Revised plan 1:100 at A3, printed at 100% | Original exterior footprint and room positions retained

Open the garden room, close off the guest wing

Before and after at 1:50 on A3 | View orientation matches the plan above

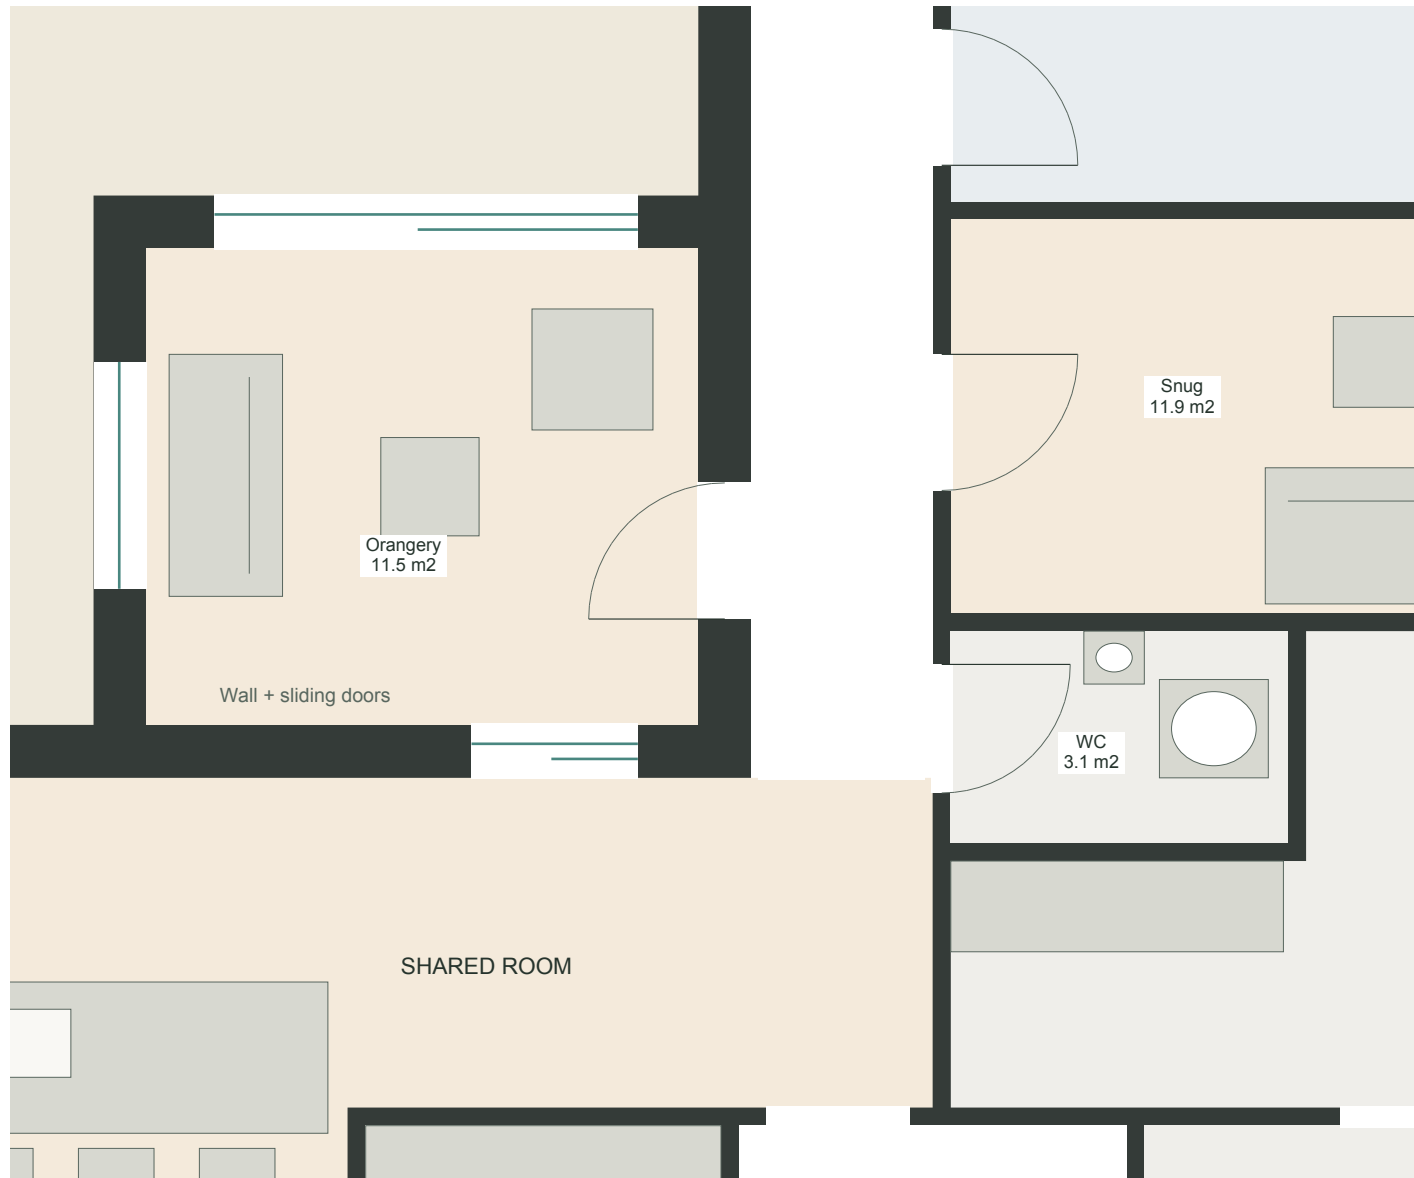
Remove the internal sliding doors and wall to the shared room.
Open the wall to the shared hall.
Relocate its door beyond the snug.

The former orangery becomes an open, year-round garden sitting area beside the main living space.

4.00 m open edge to shared living.
3.50 m open edge to shared hall.
These are wall-removal dimensions; beam bearings or posts may reduce the finished clear openings.

New 0.90 m door across the hall separates office and guest rooms.
Snug and WC stay on the shared side.

Design heating, ventilation and summer shading together with the shared room. No internal separating doors enclose the garden sitting area.

Low garden-room roof retained as the current form. The ceiling meets the taller vault at a broad opening; its overhead detail is not resolved.

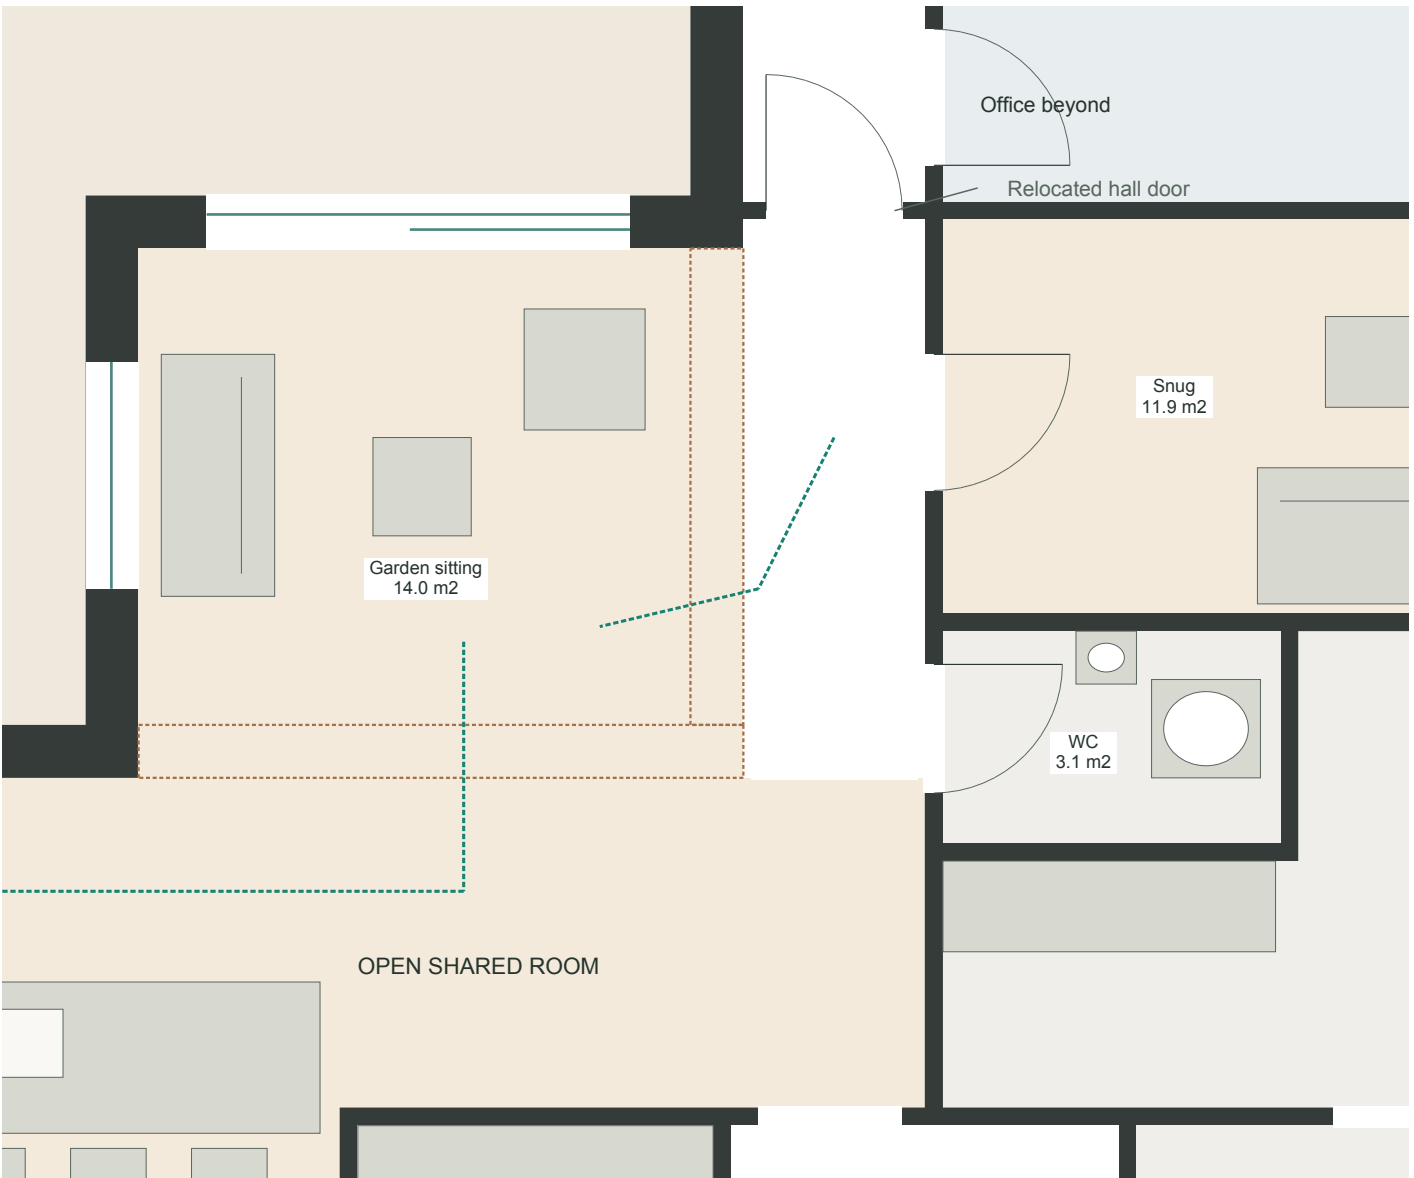
1.10 m sliding connection to the main shared room.
0.90 m hinged door to the guest hall.
Internal walls make this a separate room.

Brown dashed: former wall positions, removed in this study.
Green dashed: checked routes through the open corner.
Door beyond the snug separates office and guest rooms.

The hall door is beyond the snug when walking from shared living. It swings toward the office; the existing office door stays.
Full garden-room openings are the intent; beams, bearings and a possible corner post still require structural design.
The 14.00 m2 garden sitting zone includes former wall and doorway-threshold strips. Overall GIA does not increase.
Geometry checks cover room/furniture fit, retained doors and sampled 0.70 m routes; they do not establish structural or environmental performance.
